**City of Portland, Maine – Building or Use Permit Application** 389 Congress Street, 04101, Tel: (207) 874-8703, FAX: 874-8716

LAND USE - ZONING REPORT

REASON FOR PERMIT: 2nd Story 28' x 8' Deck

## BUILDING PERMIT REPORT

please use space below for drawing of deck with measurements.

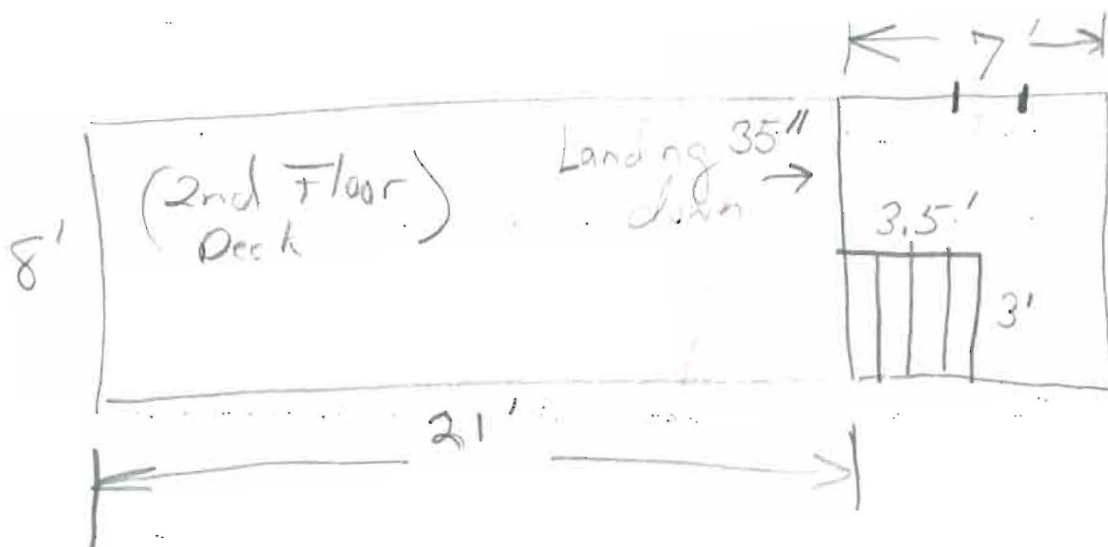
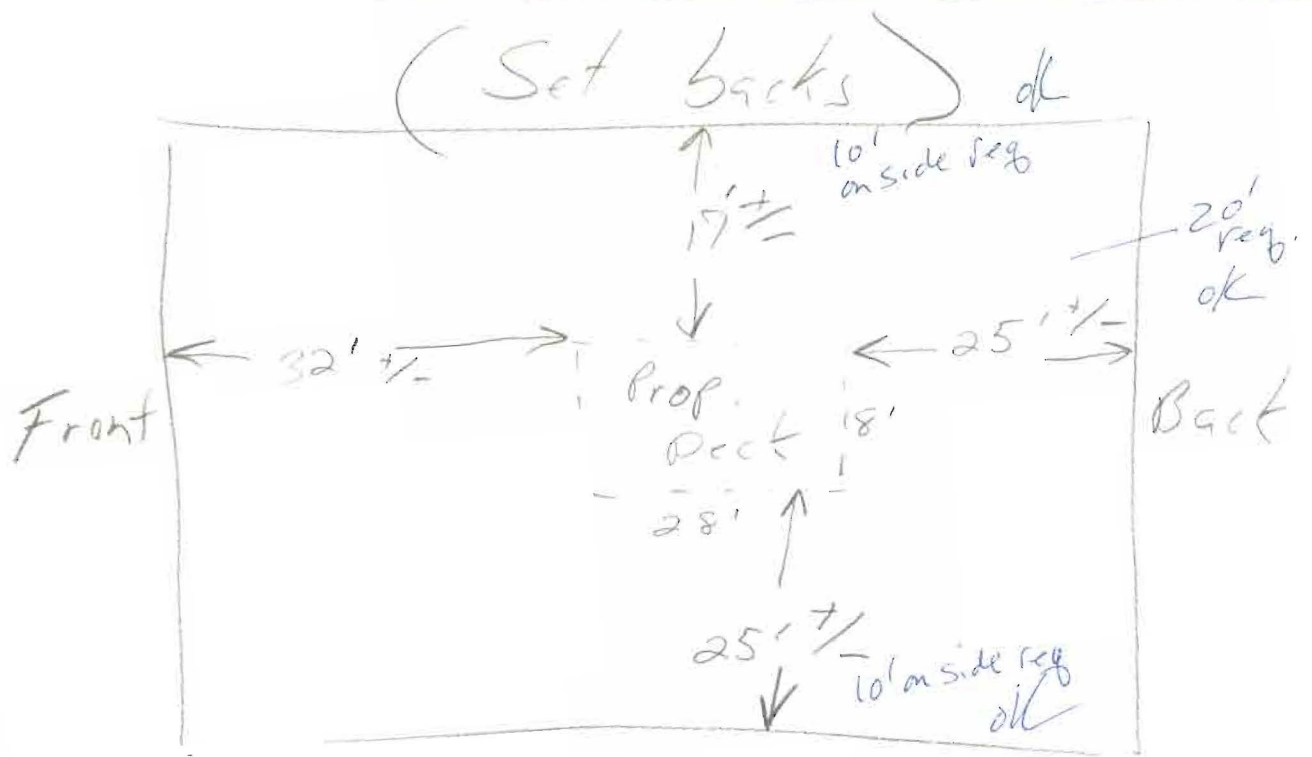
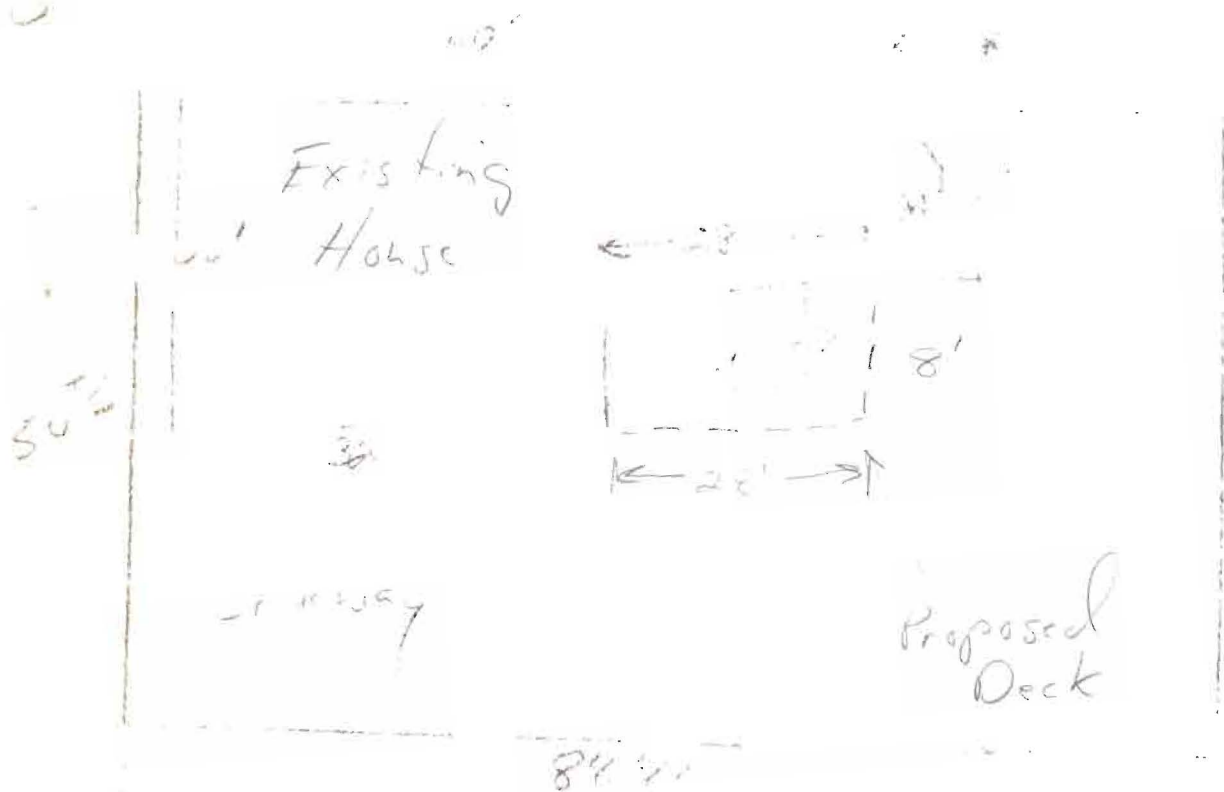
5. This property shall remain a single family dwelling. Any change of use shall require a separate permit application for review and approval.
6. Our records indicate that this property has a legal use of two units. Any change in this approved use shall require a separate permit application for review and approval.

7. Separate permits shall be required for any signage.
8. Separate permits shall be required for future decks and/or garage.
9. Other requirements of condition As we discussed, the ordinance does not

allow any open exterior stairways or fire escapes. None is  
proposed for this 2nd floor deck. Please note that no further  
exterior stairs will be allowed.
